Appendix A Typical Compartmentation Drawings for Phase 1

To assist Hawkins Brown in the preparation of fire drawings for Phase 1 work, the following mark-ups are provided.

-	11.10.2017	Issued for information.	TP
REV	DATE	DESCRIPTION	BY
PROJECT UCL IOE PHASE 1 20 BEDFORD WAY. WC1H OAL			
CLIENT UCL IOE			
LOCATION LEVEL 2 WING

DRAWING TITLE GENERAL ARRANGEMENT PLAN (FINAL LAYOUT)			
STATUS INFORMATION			SCALE 1:100 @ A1
DRAWN BY TP	CHECKED BY RA	DATE 15.09.2017	REVISION P03
DRAWING NUMBER UCL-IOE-0100-WA-02-DR-A-72-0001

Figure 6-5: Level 03 between cores B to C, existing fire brigade access and hose coverage by providing dry riser outlets in Cores B & C

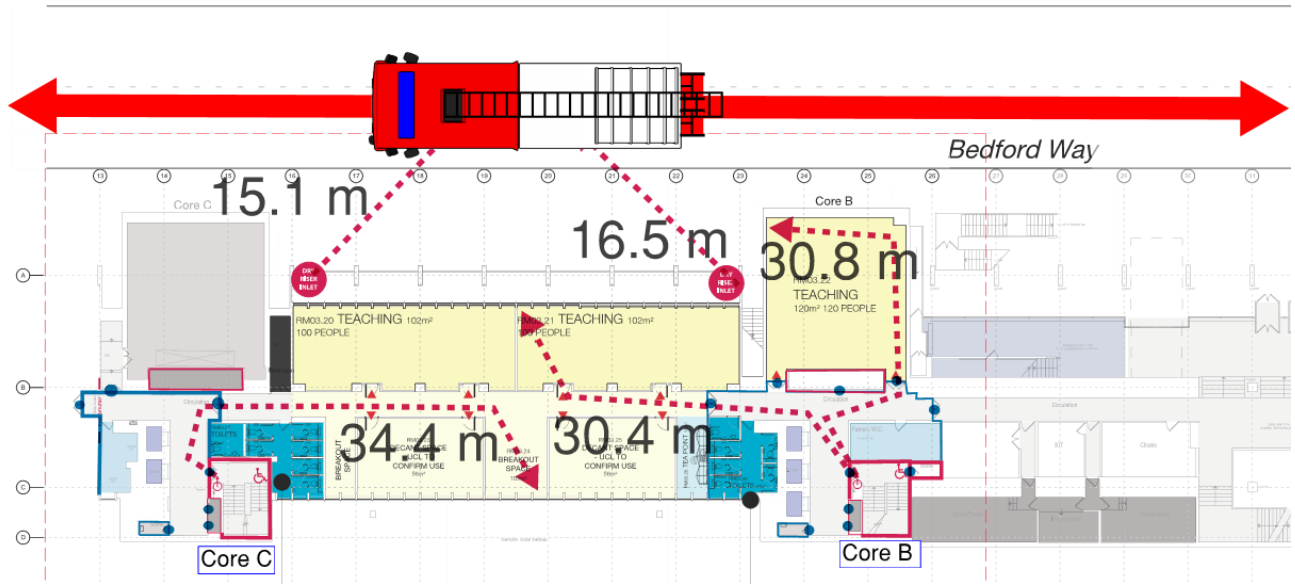
In the existing situation dry riser outlets are located in stairs A to C at every two levels. During Phase works, 1 it is to be ensured that dry riser outlets are provided in stairs B to C at Level 03, and stair A at levels 04 and 05. It is recommended for dry riser outlets to be provided at all levels for the final design i.e. as each future phase is completed on a phase-by-phase basis.

Figure 6-6: Level 02 Wing smoke clearance requirements

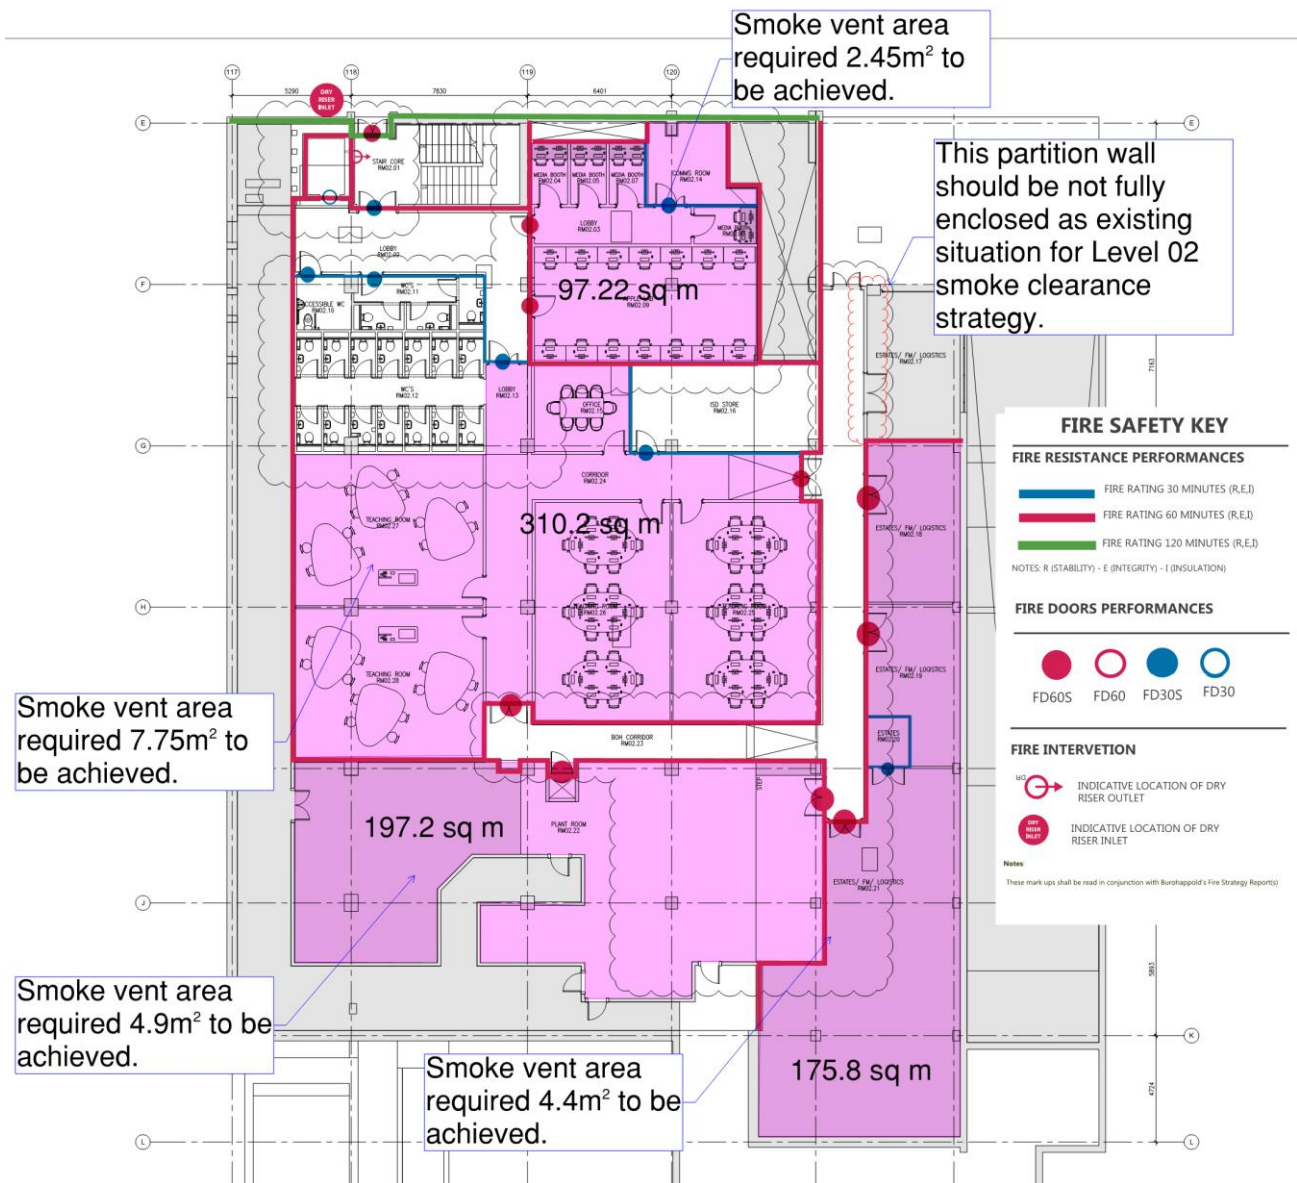
The Level 02 is proposed to be separated into fire compartments being vented via fire service opening doors to external for assisting the smoke clearance strategy, see Figure 6-6 . The proposed smoke clearance strategy is improving significantly the existing situation (i.e. this level was used as workshops areas with no venting or firefighting facilities), by providing fire service access, compartmentation and as much smoke venting as practicably possible. The below is considered reasonable given existing constraints and has been discussed and agreed with the London Fire Brigade.

The break out space compartment is 310m² excluding low risk spaces such as toilets and protected lobby, thus 7.75m² of smoke vent area should be achieved to meet the recommended 2.5%. It is proposed for this venting area to be provided via fire service opening doors to the permanently vented circulation corridor and through opening the doors in Stair V into the service road. Assuming that the doors height is 2m, three doors of 1300mm wide, a total area of 7.8m² is achieved. The cross venting criterion is also met. The back-of-house circulation corridor is considered as an external space since it is permanently vented via the last room being meshed/grilled walls.

The Apple Lab and Media Booth rooms form a 97.2m² compartment, therefore 2.45m² of smoke vent area should be achieved to meet the recommended 2.5%. This is proposed to be provided via the opening the doors into the external circulation space and doors of Stair V, thus a total area of 2.6m² it is achieved. No cross venting would be achieved unless smoke is vented through the breakout space. This is considered reasonable for this compartment since in this corner, the risk associated with these rooms from heat and smoke build-ups are no different than ground floor rooms.

The plant room compartment is 197.2m² total area therefore a smoke vent area of 4.9m² is required based on achieving the recommended 2.5%. This is proposed to be achieved via doors opening into the existing exhaust plenum, and doors to the back of house corridor. The back-of-house circulation corridor is considered as an external space since it is permanently vented via the last room being meshed/grilled walls.

The UCL Estates offices are of total area 204.4m² thus a smoke vent area of 5.1m² is required based on achieving the recommended 2.5%. This is proposed to be achieved via doors opening to the permanent ventilated corridor. The doors are 1300mm wide and 2m height and a total area of 7.8m² is provided.

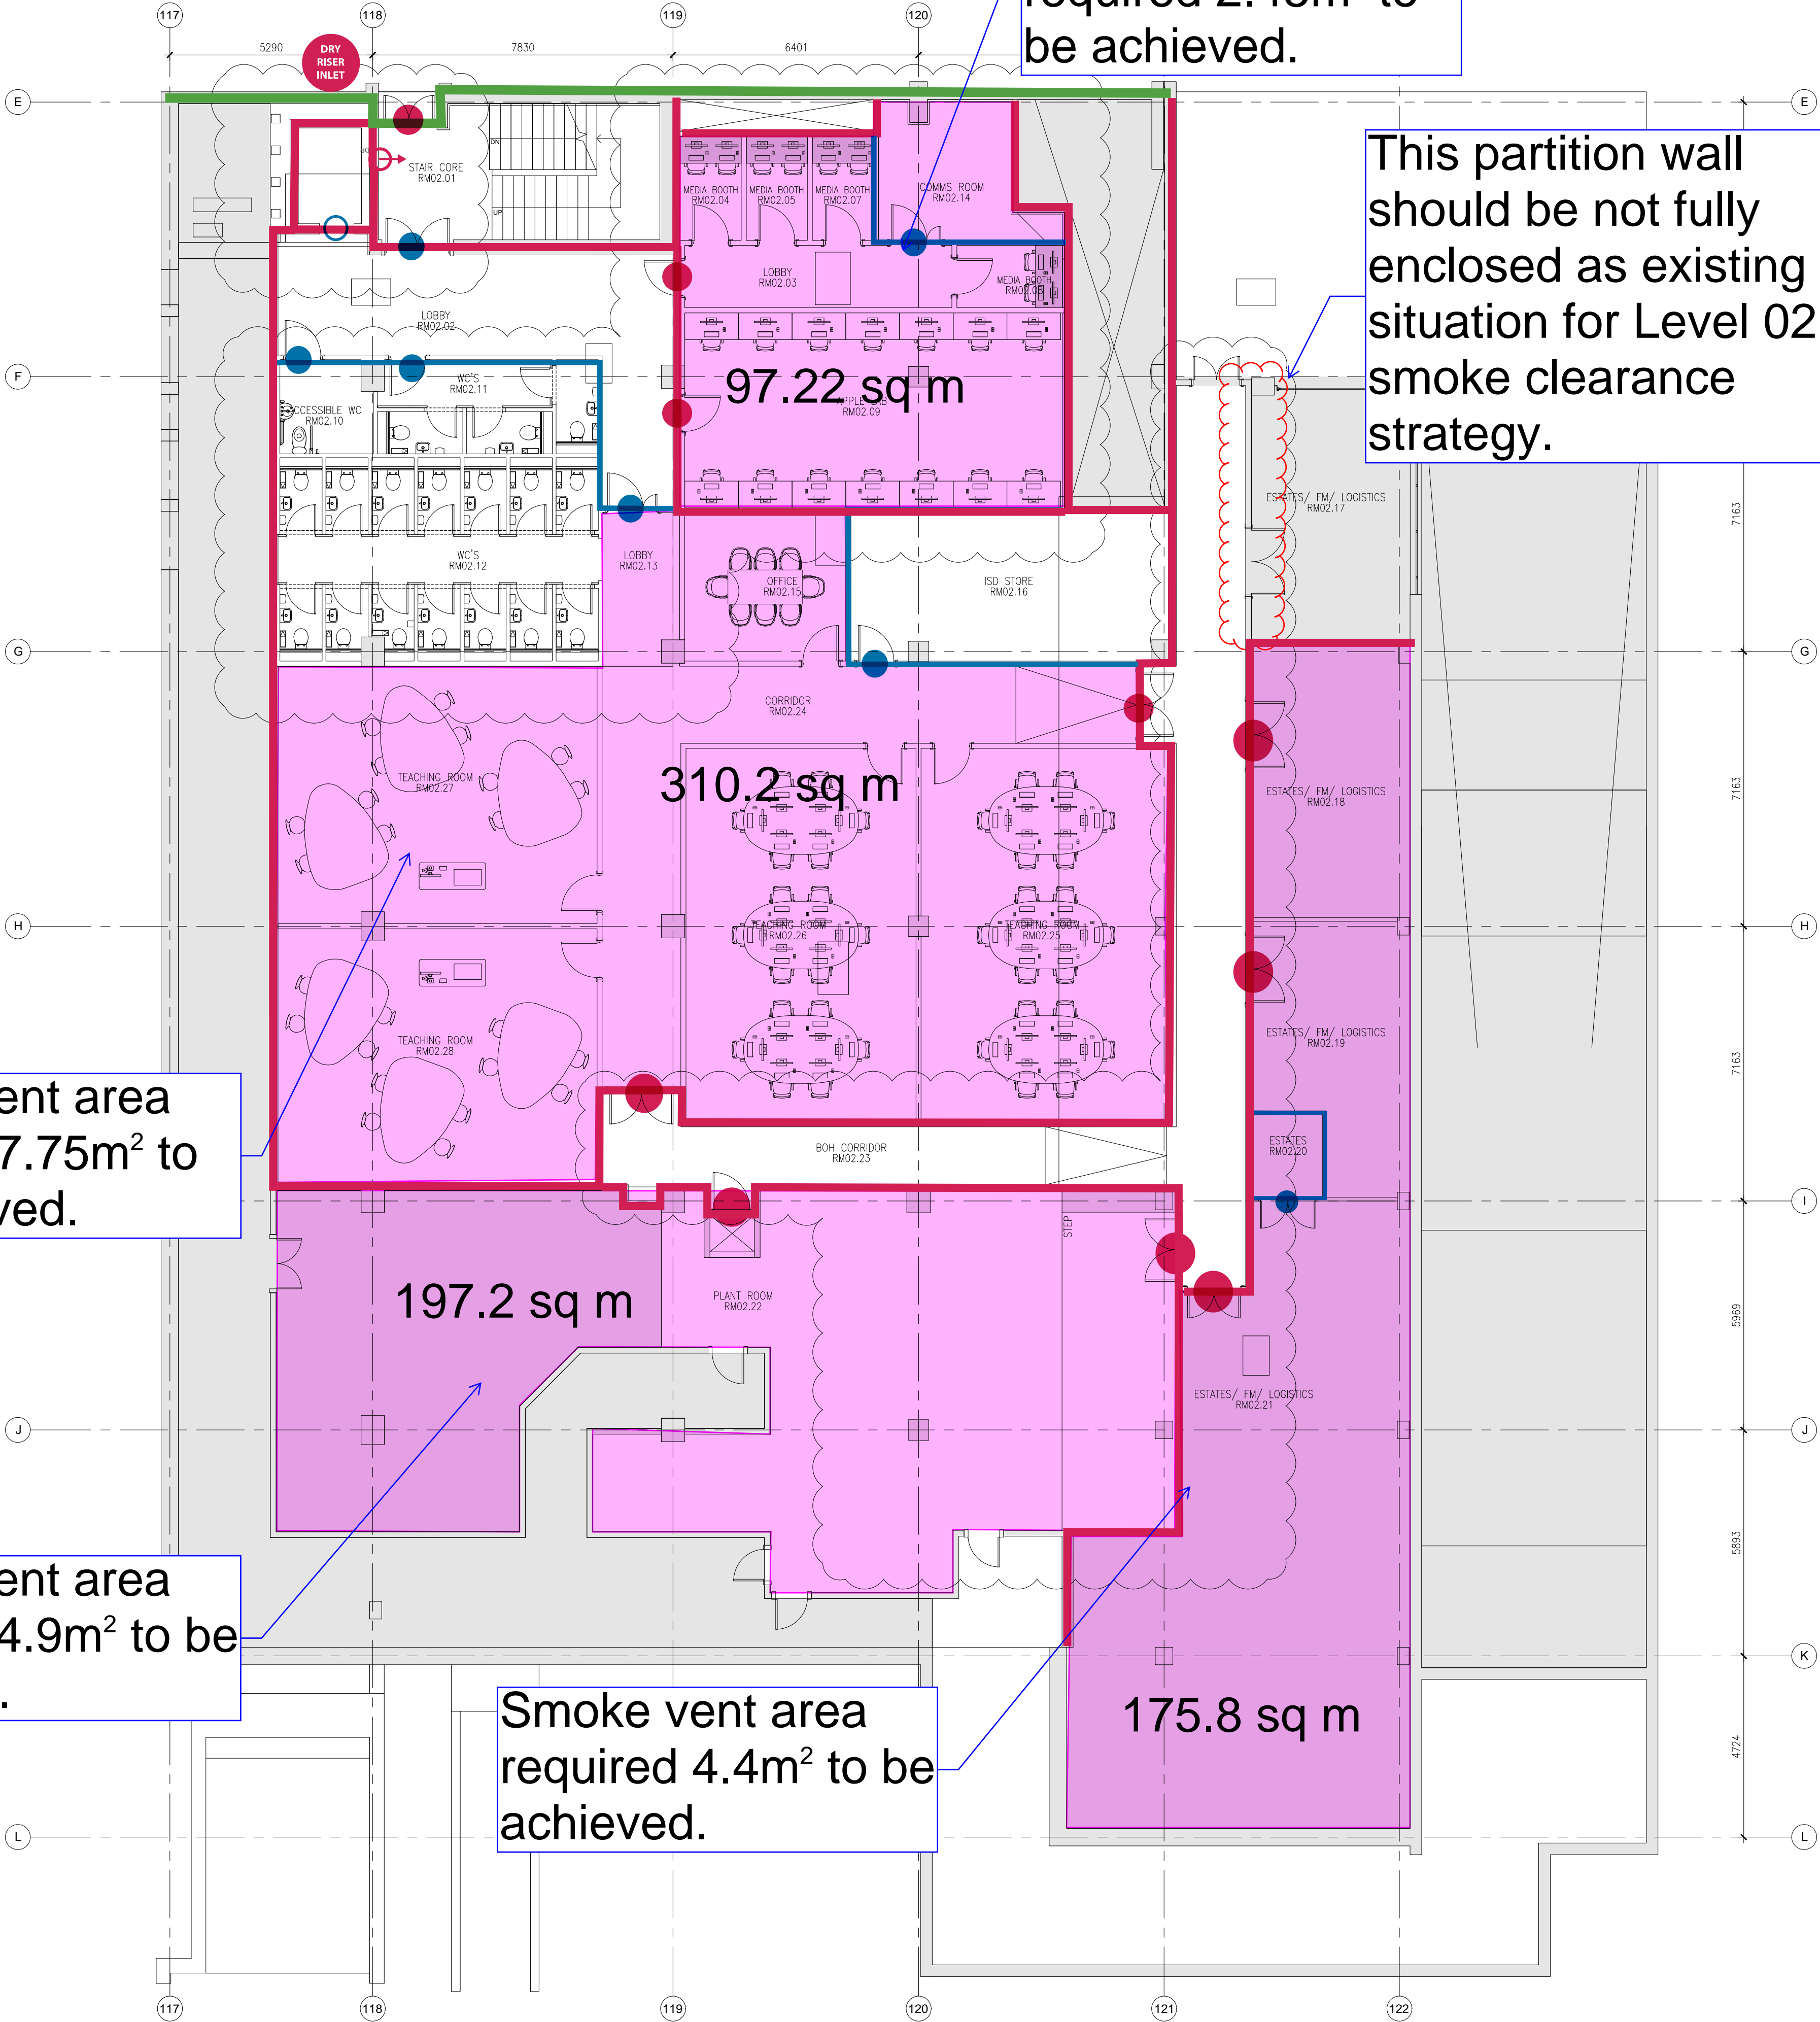
Smoke vent area required 2.45m² to be achieved.

This partition wall should be not fully enclosed as existing situation for Level 02 smoke clearance strategy.

Smoke vent area required 7.75m² to be achieved.

Smoke vent area required 4.9m² to be achieved.

Smoke vent area required 4.4m² to be achieved.
